S4.55 AMENDMENTS:

MOD2019/0585

PROJECT
TWO SEMI-DETACHED DWELLINGS WITH BASEMENT CARPARKING:
52 LAUDERDALE AVENUE, FAIRLIGHT, NSW
CLIENT
DAVID ALLEN & THE CASEY FAMILY TRUST

DRAWING TITLE	PROJECT		
ROOF/SITE PLAN	LAF		
SCALE	STATUS	NUMBER	REVISION
1:100 @A3	S4.55	A1.06	S4.55

DRAWING TITLE	NORTH ELEVATION		PROJECT	LAF
SCALE	STATUS	NUMBER	REVISION	
1:100 @A3	s4.55	A2.03	P1

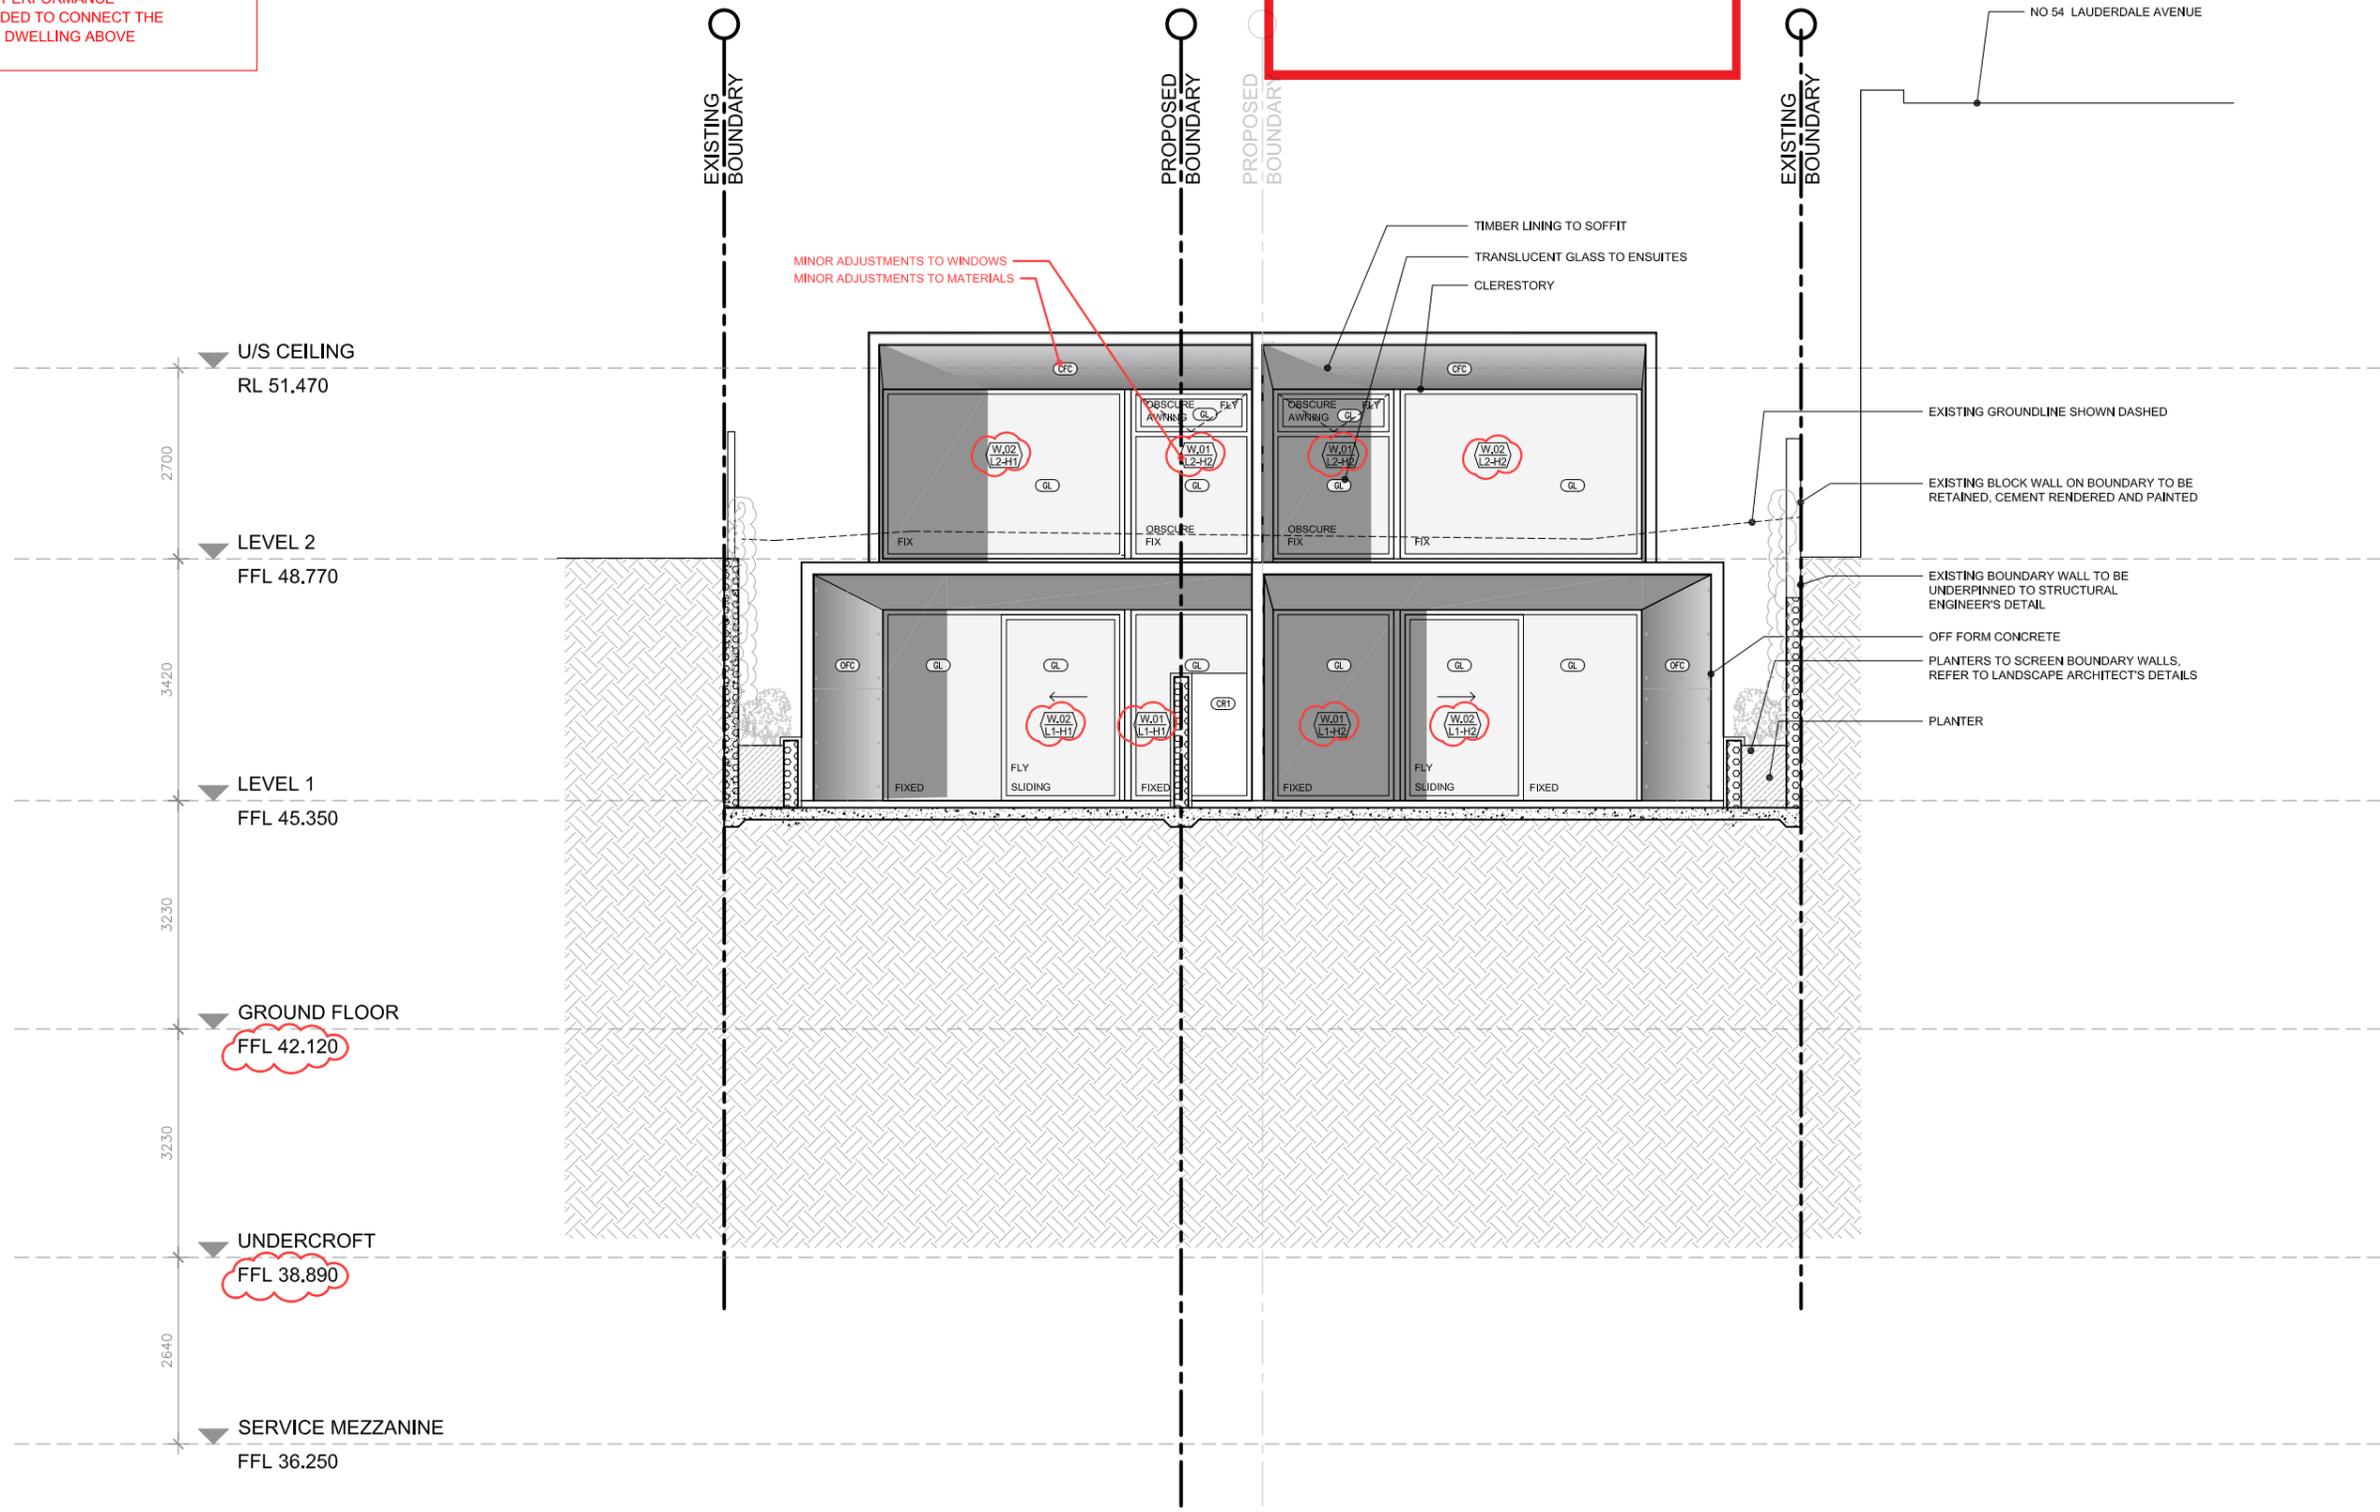
- ADJUSTMENTS OF UNDERCROFT AND GROUND FLOOR LEVELS TO INCREASE CEILING ZONE TO ALLOW FOR AN HRV SYSTEM, OVERALL BUILDING HEIGHT STAYS THE SAME
- MINOR ADJUSTMENTS TO THE FENCE AND GARDEN AS A RESULT OF ABOVE
- MINOR EXTERNAL ADJUSTMENTS DUE TO ABOVE POINTS AND DECREASED WINDOW SIZES FOR IMPROVED THERMAL PERFORMANCE
- INTERNAL STAIR ADDED TO CONNECT THE BASEMENT WITH THE DWELLING ABOVE

DRAWING TITLE	PROJECT		
EAST ELEVATION	LAF		
SCALE	STATUS	NUMBER	REVISION
1:100 @A3	S4.55	A2.04	S4.55

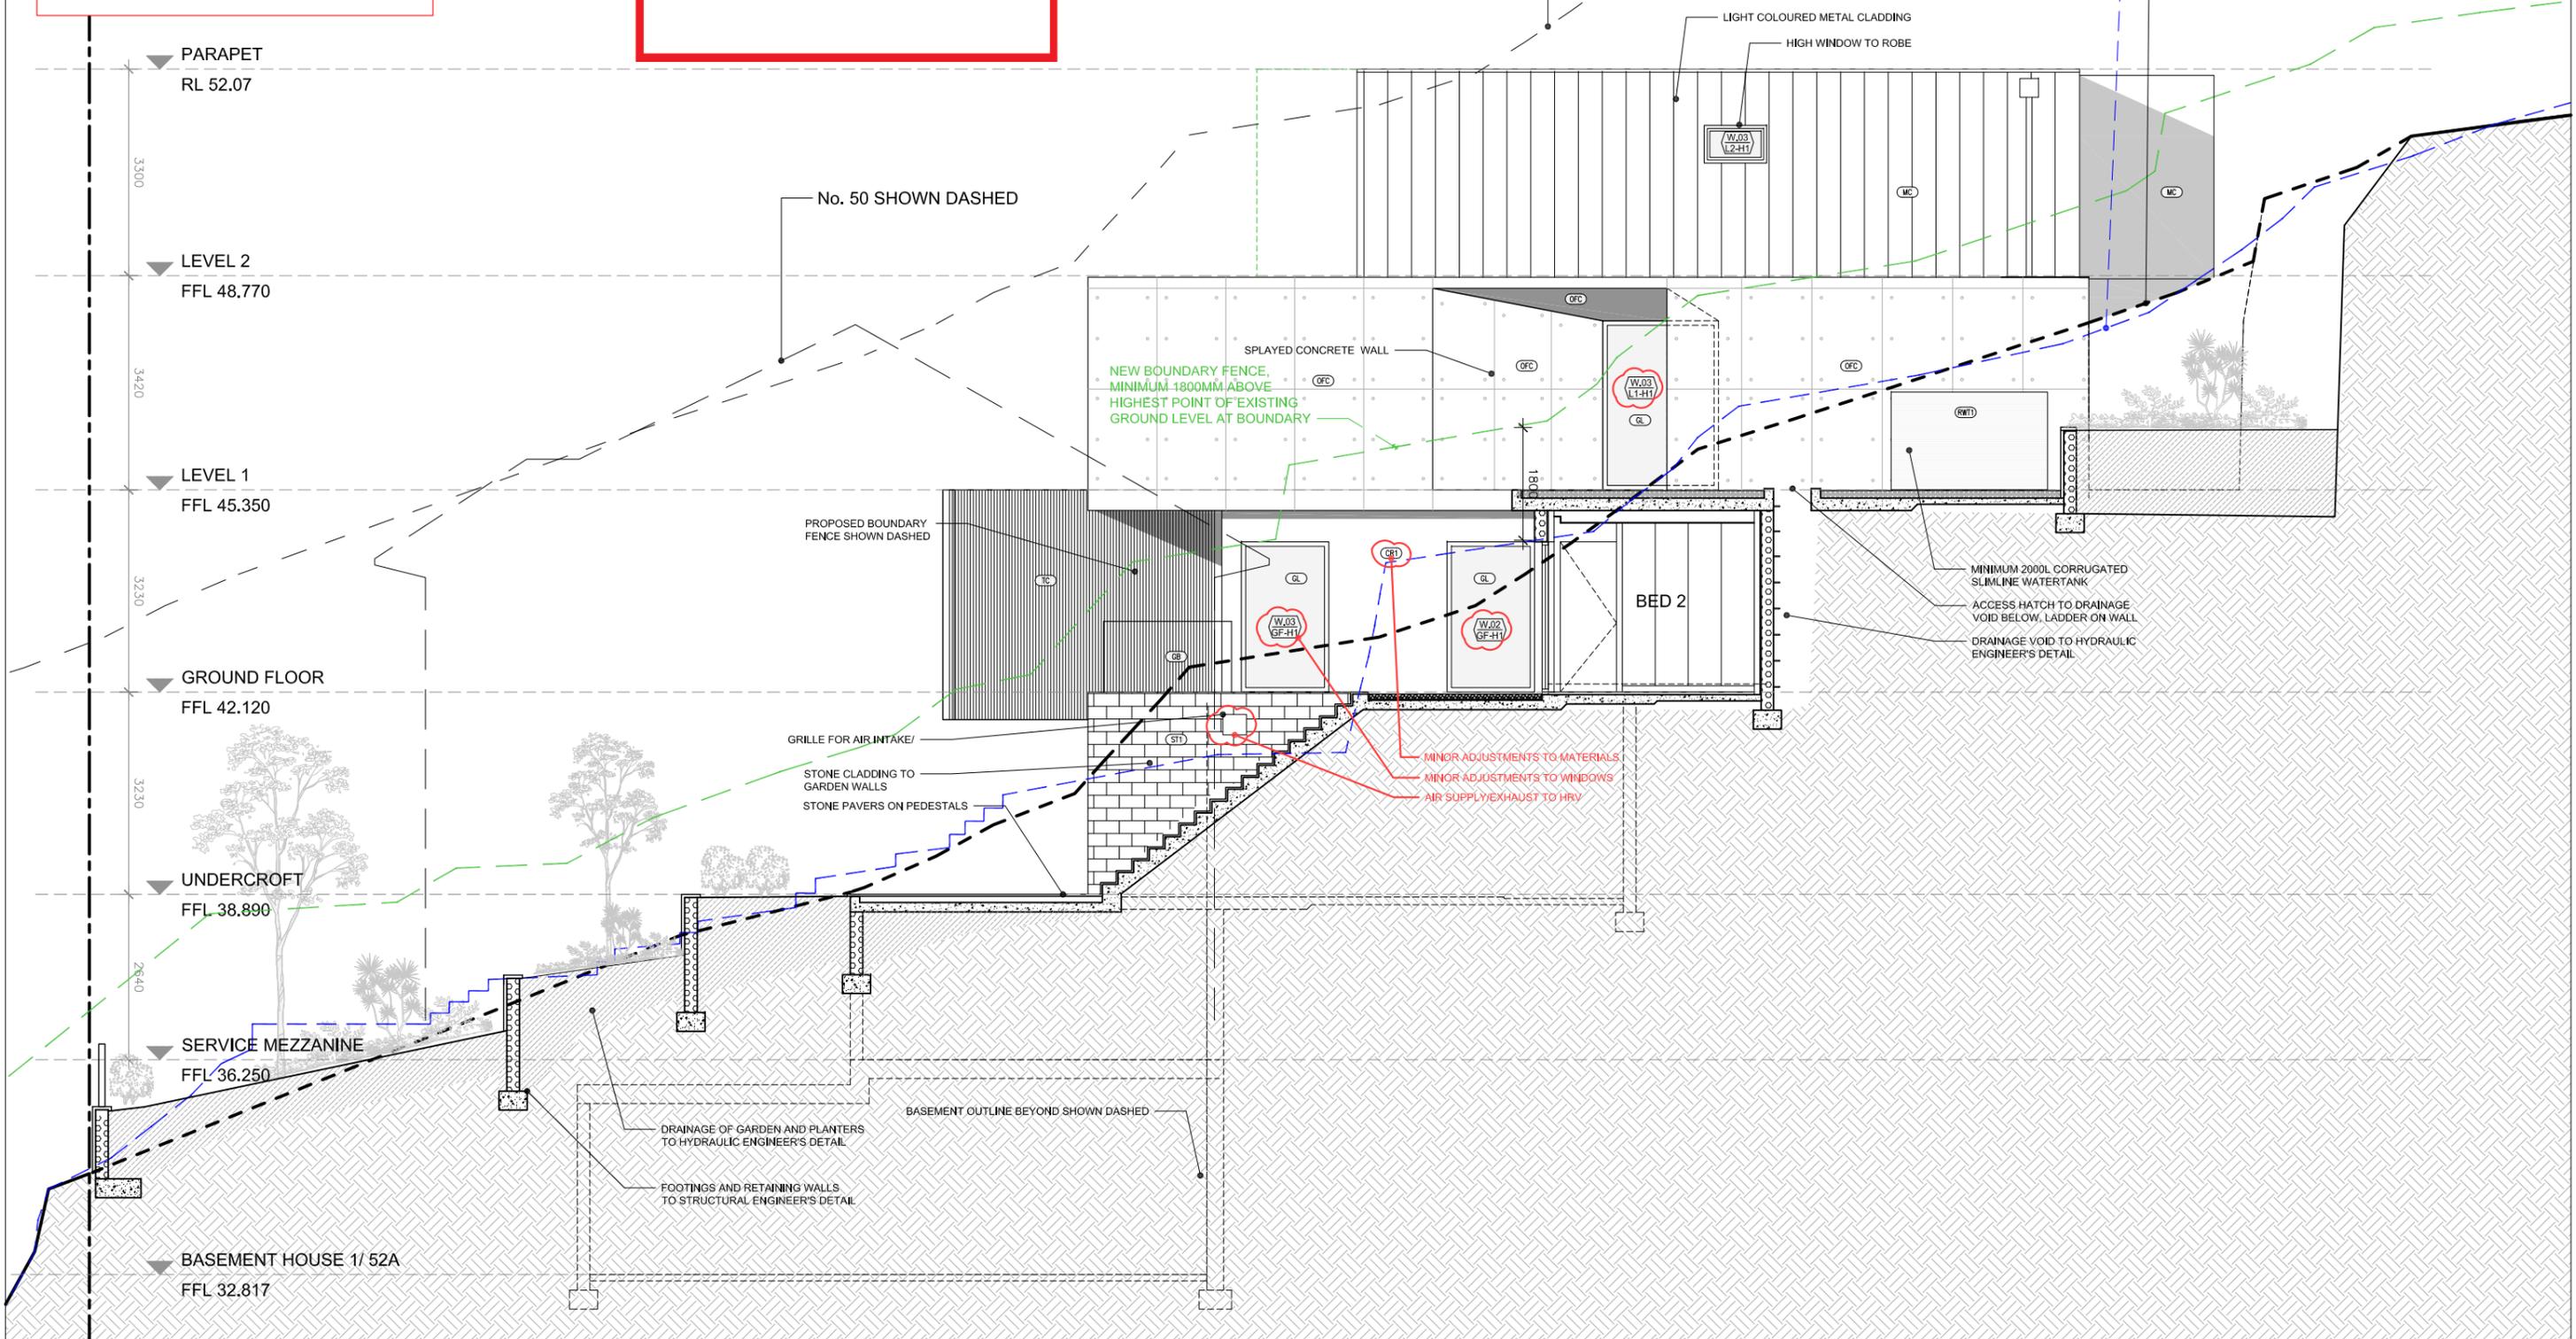
- ADJUSTMENTS OF UNDERCROFT AND GROUND FLOOR LEVELS TO INCREASE CEILING ZONE TO ALLOW FOR AN HRV SYSTEM, OVERALL BUILDING HEIGHT STAYS THE SAME
- MINOR ADJUSTMENTS TO THE FENCE AND GARDEN AS A RESULT OF ABOVE
- MINOR EXTERNAL ADJUSTMENTS DUE TO ABOVE POINTS AND DECREASED WINDOW SIZES FOR IMPROVED THERMAL PERFORMANCE
- INTERNAL STAIR ADDED TO CONNECT THE BASEMENT WITH THE DWELLING ABOVE

DRAWING TITLE	PROJECT		
DRIVEWAY ELEVATION	LAF		
SCALE	STATUS	NUMBER	REVISION
1:100 @A3	s4.55	A5.03	S4.55

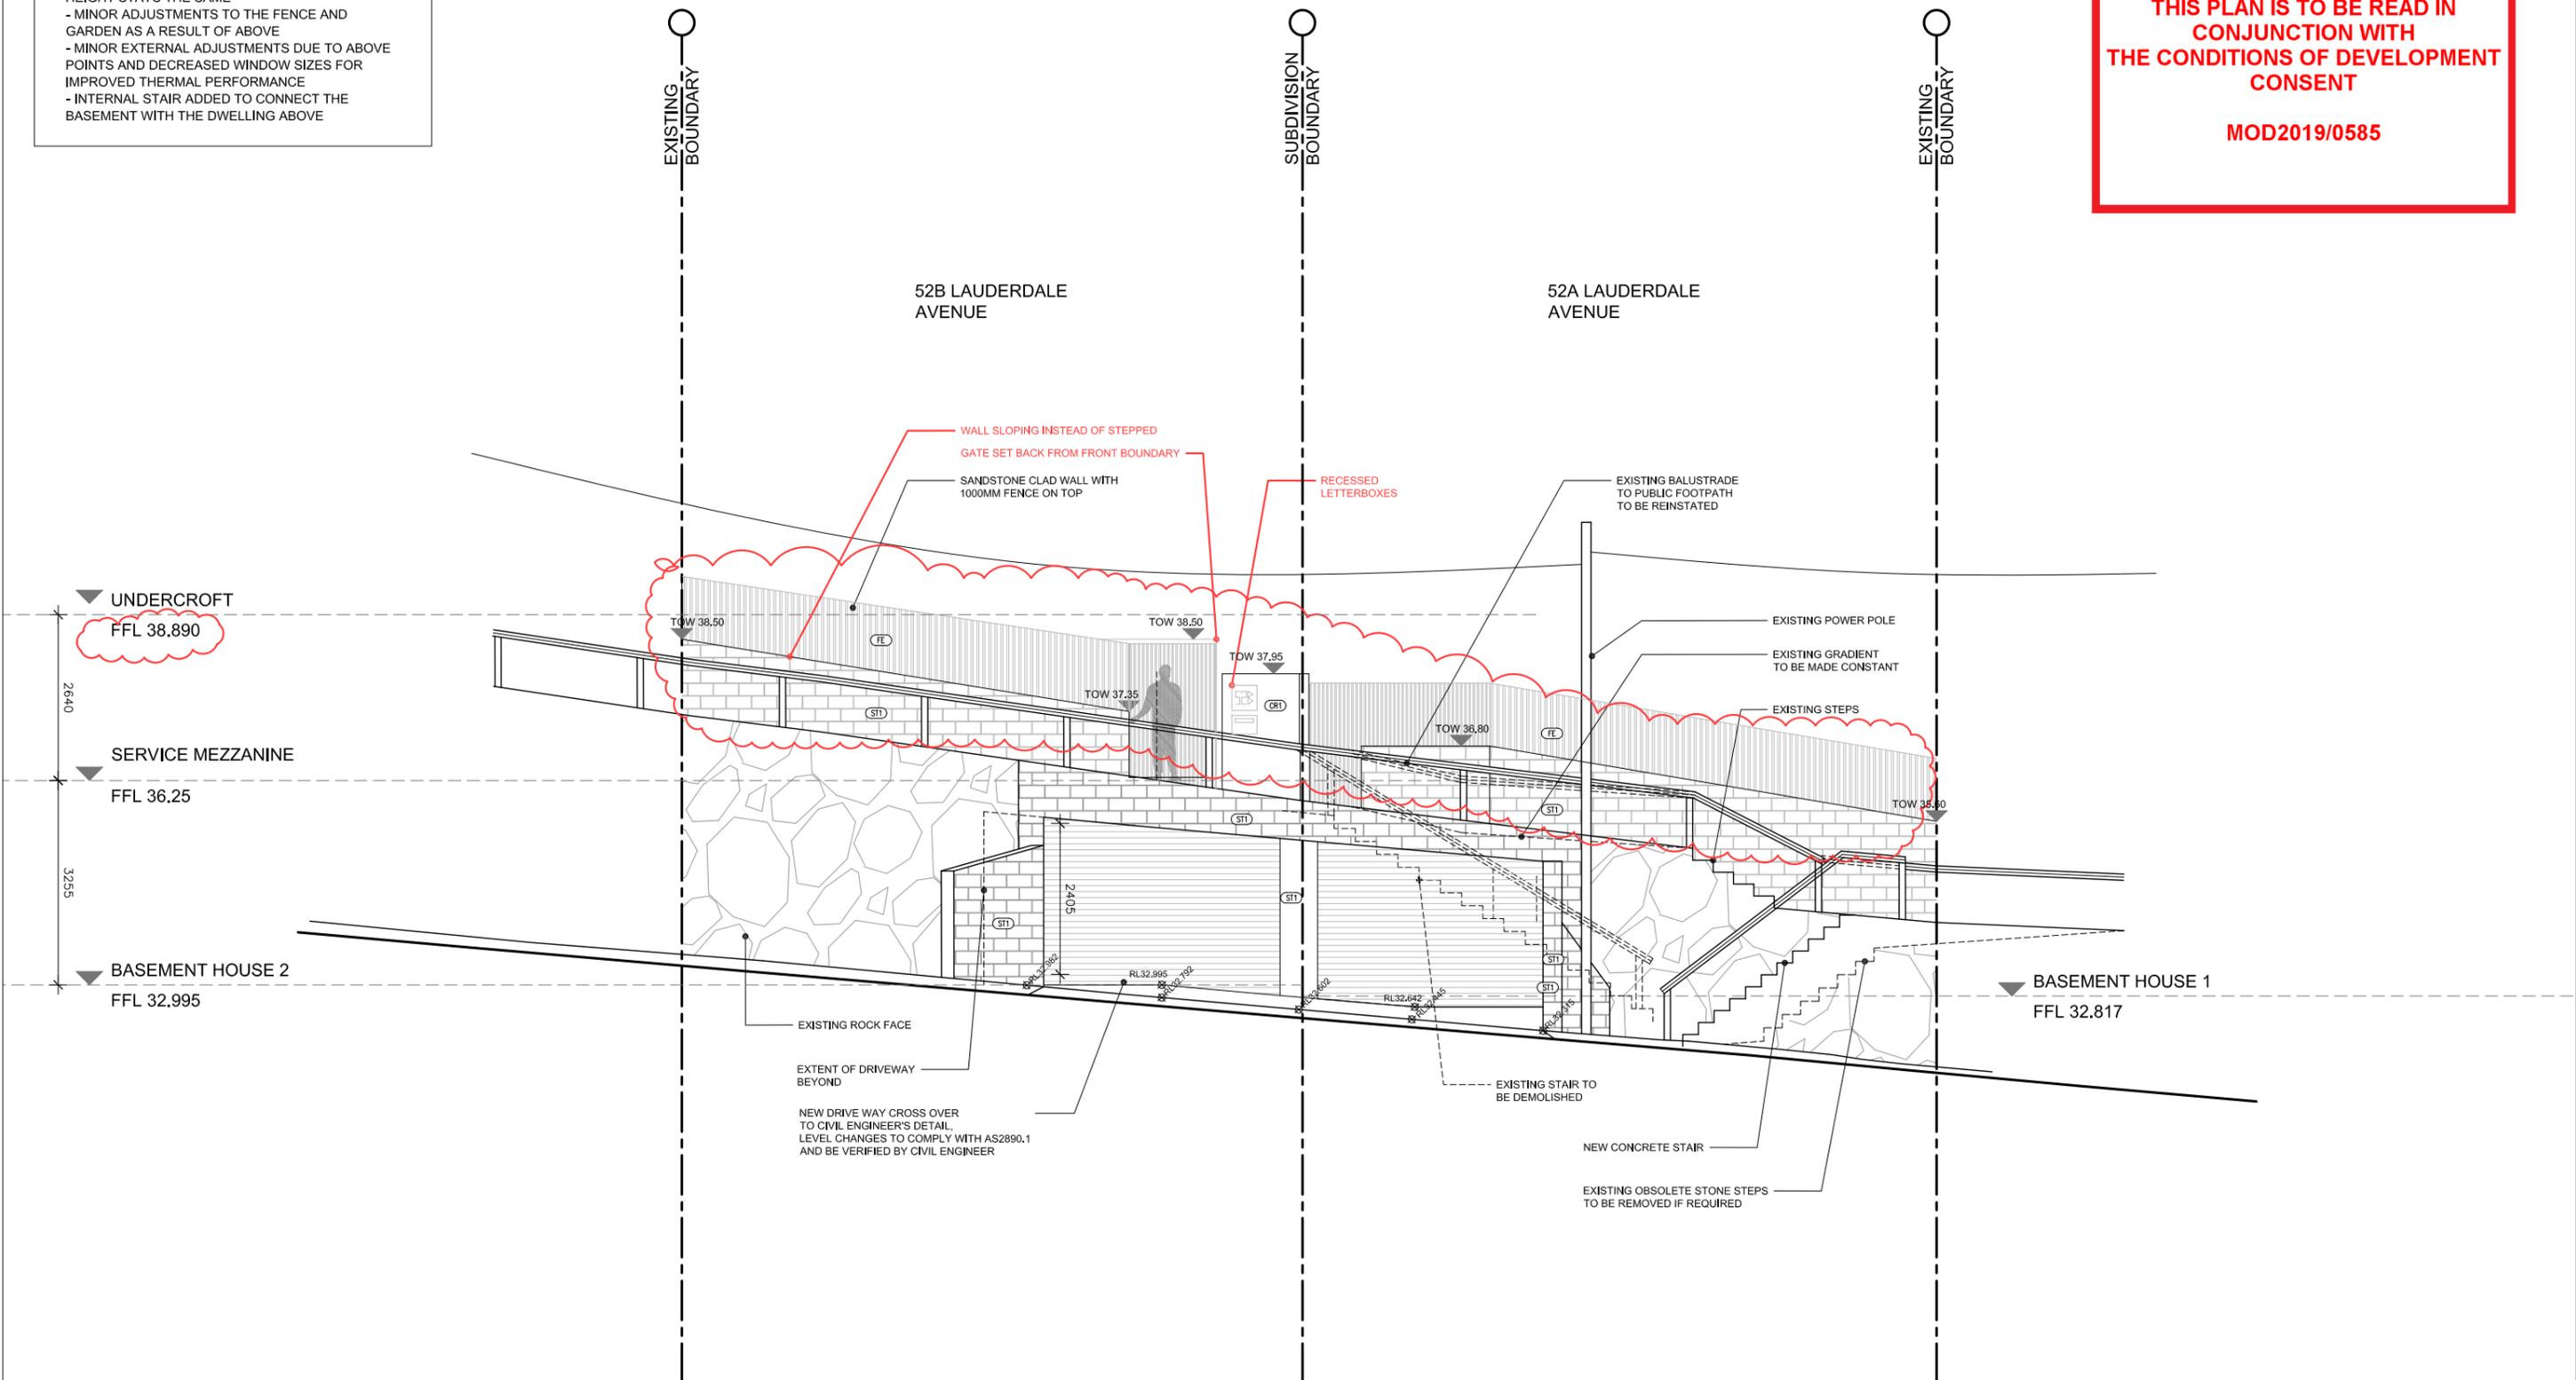
- ADJUSTMENTS OF UNDERCROFT AND GROUND FLOOR LEVELS TO INCREASE CEILING ZONE TO ALLOW FOR AN HRV SYSTEM, OVERALL BUILDING HEIGHT STAYS THE SAME
- MINOR ADJUSTMENTS TO THE FENCE AND GARDEN AS A RESULT OF ABOVE
- MINOR EXTERNAL ADJUSTMENTS DUE TO ABOVE POINTS AND DECREASED WINDOW SIZES FOR IMPROVED THERMAL PERFORMANCE
- INTERNAL STAIR ADDED TO CONNECT THE BASEMENT WITH THE DWELLING ABOVE
